RE: Blue Water RV Park Proposal

Following please find our responses, in *italics*, to your comments dated March 30, 2002

RE: Base Flood Elevation Analysis
Preston RV Park

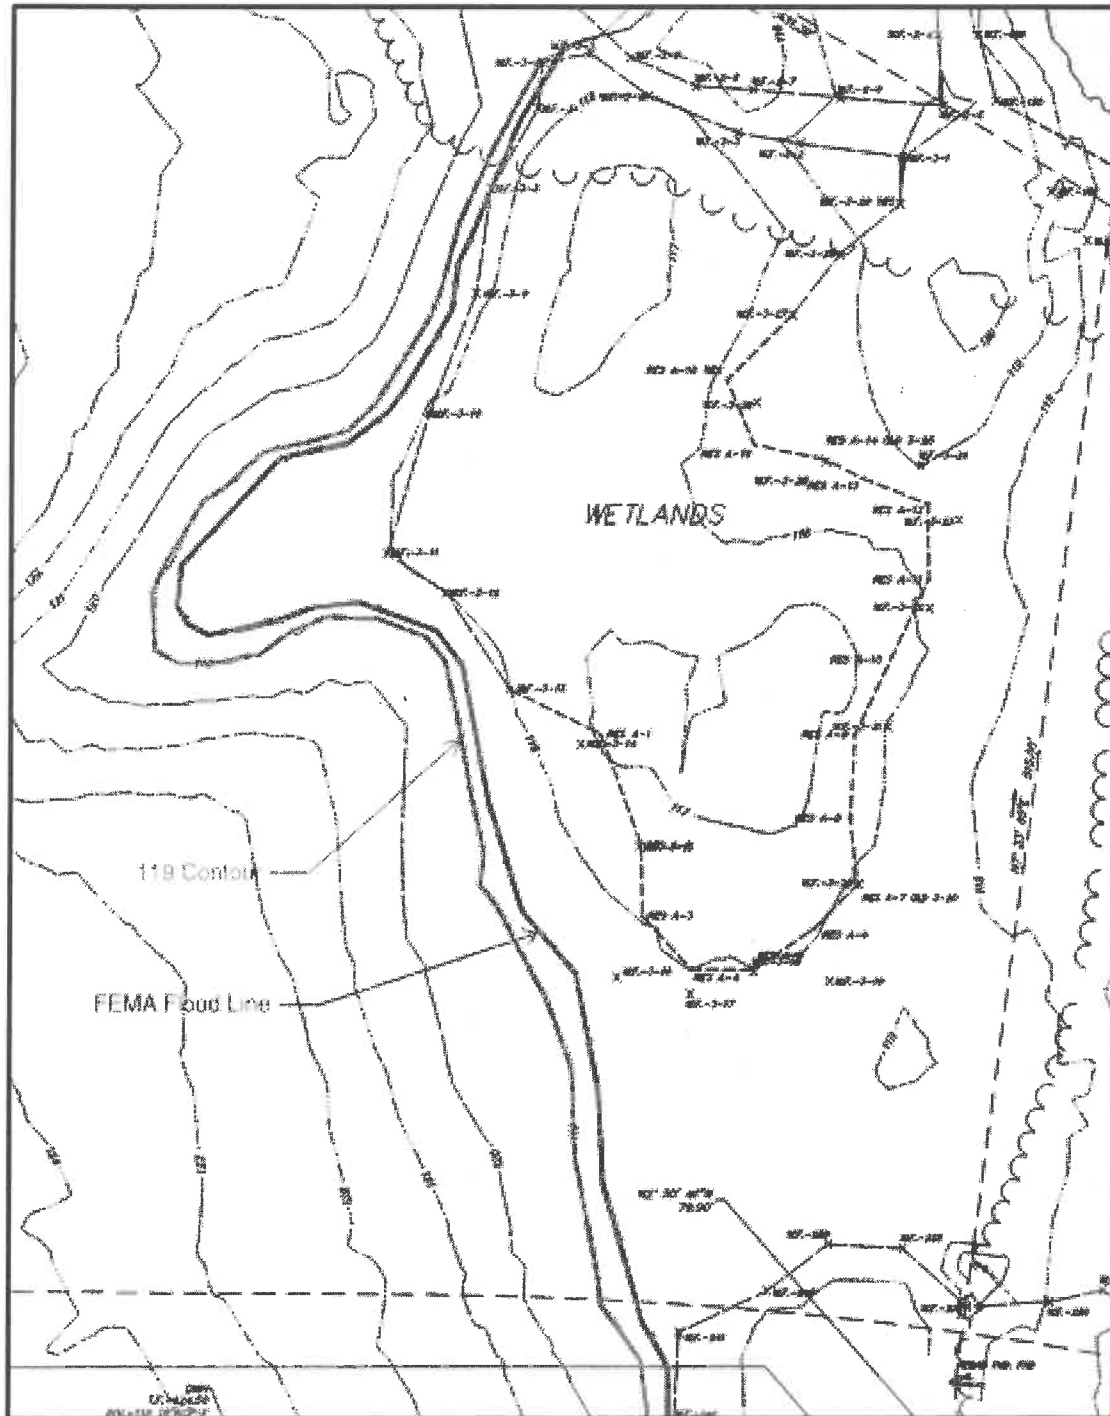
- a) A registered professional engineer should determine the BFE in accordance with accepted hydrologic and hydraulic engineering practices and document the technical methods used. Studies, analysis, and computations should be submitted in sufficient detail to allow thorough review. FEMA developed a guide to assist in determining the BFE, the link is as follows:
https://www.fema.gov/sites/default/files/documents/fema_approx-zone-a-guide.pdf

Step 4 – Determine if this method is within the acceptable accuracy limits. The floodplain boundary must generally conform with the contour lines along the flooding source in question. The difference between the water-surface elevations determined on the right overbank and the left overbank must be within one-half of the map contour interval. For lacustrine flooding sources, the difference between the highest and lowest determined water-surface elevations around the flooding source must be within one-half of the map and contour interval. Otherwise, this method is not acceptable.

The floodplain line for the right overbank of Indiantown Brook lines up almost exactly parallel to the 119 contour and indicates a BFE of elevation 118.8. We do not have contour data on the left overbank as that is located on the adjacent property, and we did not perform topographical survey on the adjacent property. Given that near parallel nature of the FEMA BFE line and the 119 contour, it is our professional opinion that this method is acceptable.

By interpolating between the parallel 119 contour and the FEMA BFE line, it is our professional opinion that the approximate BFE in this area is elevation 118.8.

Compensatory Storage Areas

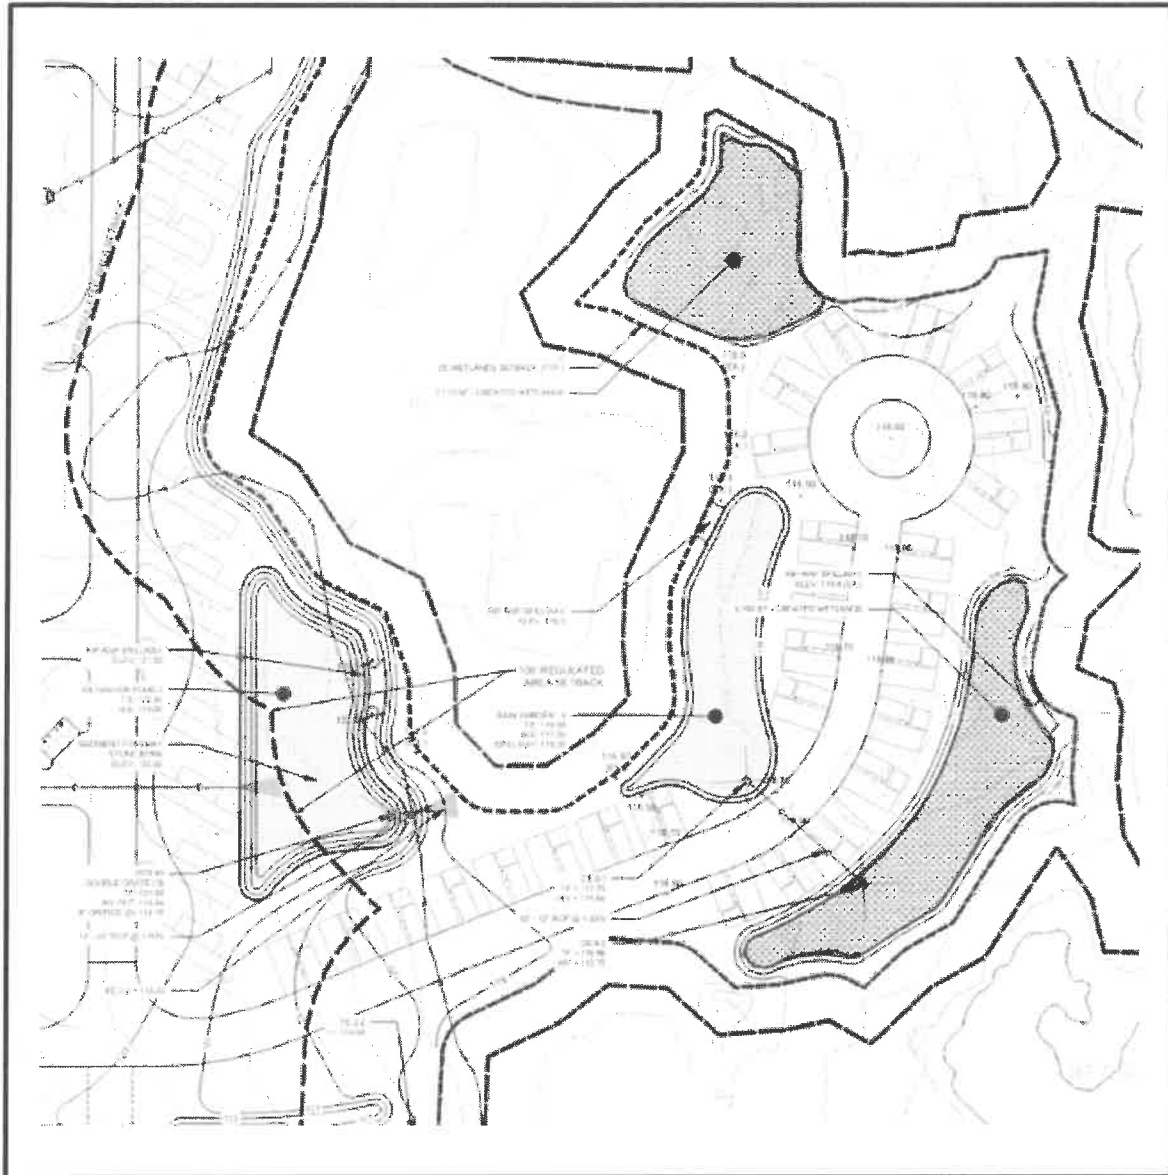
- b) The flood impact statement is vague and needs clarification. Based on the sketch provided, it appears that the two cut areas are within the current flood hazard area. Please verify that this addresses compensatory storage even though the compensatory storage is provided in the floodplain. Also, ground water levels should be investigated in the area of the excavation and noted in the flood impact study. Highlight the compensatory storage location on your map.

The newly created wetlands areas were designed specifically to address compensatory storage requirements. However, those areas were not analyzed in a vacuum. A surface-to-surface comparison (existing vs. proposed) within the floodplain was performed to ensure compensatory storage requirements are met. The two (2) areas of created wetlands are highlighted on the plan. A colored depiction has been included in the base flood elevation analysis attached to this response letter.
